A M Fashion

Mazu Khan Bazar, Harbaid, Gazipur-1710.

1st February 2021

Building Information

Stair on south-west side

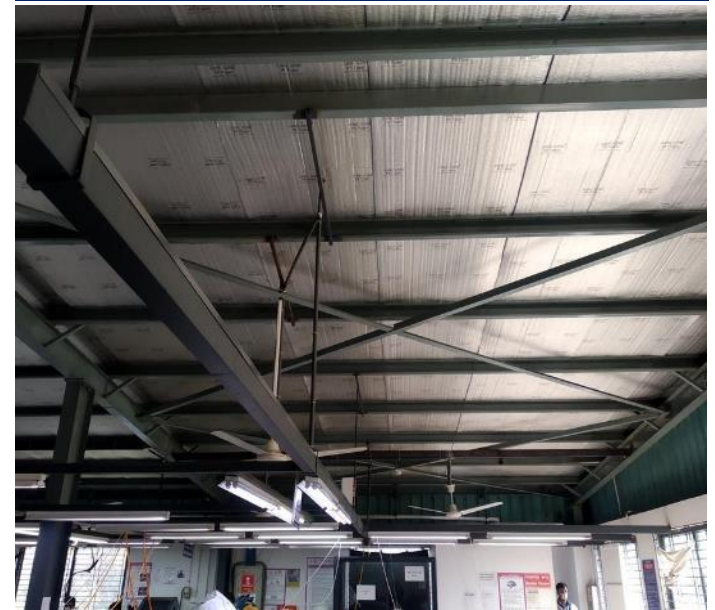
Connections of Part-A were found both bolted & welded. In Part-B, connections were found as welded. But in structural drawing, no connection details was provided.

There are two steel stairs on North-West and South-West side of Part – A of the structure. No details of any of the stairs was provided in the drawing. Moreover, bracing layout and bracing details were not incorporated in the drawing.

As per BNBC every building or structure designed shall have its design documents prepared in accordance with the provision of Section 1.9.1. The design document shall include a design report, and a set of structural drawings, which shall be prepared in compliance with section 1.9.1.1 and section 1.9.1.2 as per BNBC. During the inspection, the drawings were found incomplete and design report was not available which is required to be prepared in compliance with section 1.9.1 (Part-6, BNBC 2006).

Section of Part – B without any dimensions

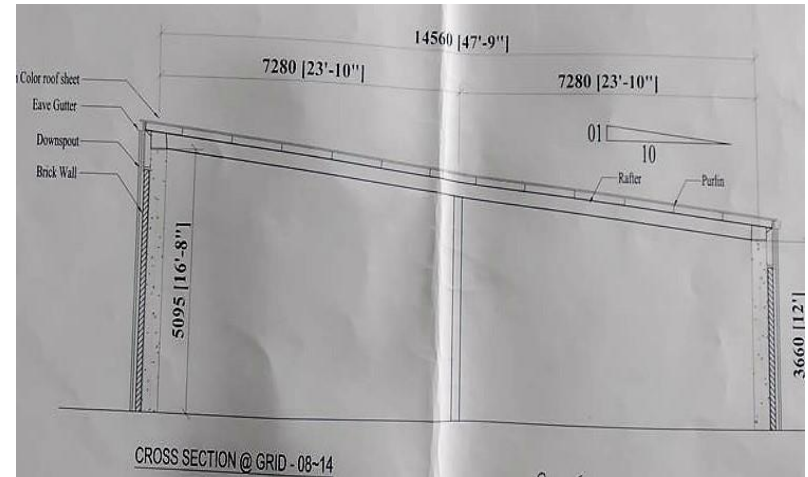
The provided section of Part – B has no dimensions mentioned. Moreover, section of grid- 1, 7 & 15 was not included in the provided as-built drawings.

RC column to rafter connection

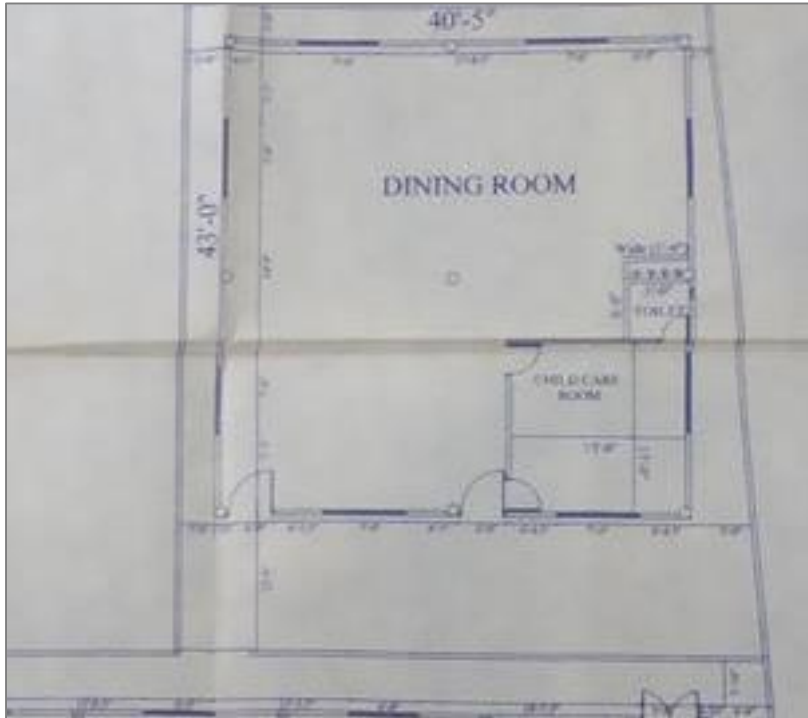
The steel roof shed did not have specified load path to transfer lateral loading. Also, apparently unclear connection between RC column to rafter was found. Factory engineer is required to specify the load path and connection of the structure. Moreover, check the lateral stability of the shed as well as the adequacy of the connection.

As per BNBC every building or structure designed shall have its design documents prepared in accordance with the provision of Section 1.9.1. The design document shall include a design report, and a set of structural drawings, which shall be prepared in compliance with section 1.9.1.1 and section 1.9.1.2 as per BNBC. Factory engineer is required to prepare Engineering Assessment (EA), in compliance with section 1.9.1 (part-6, BNBC).
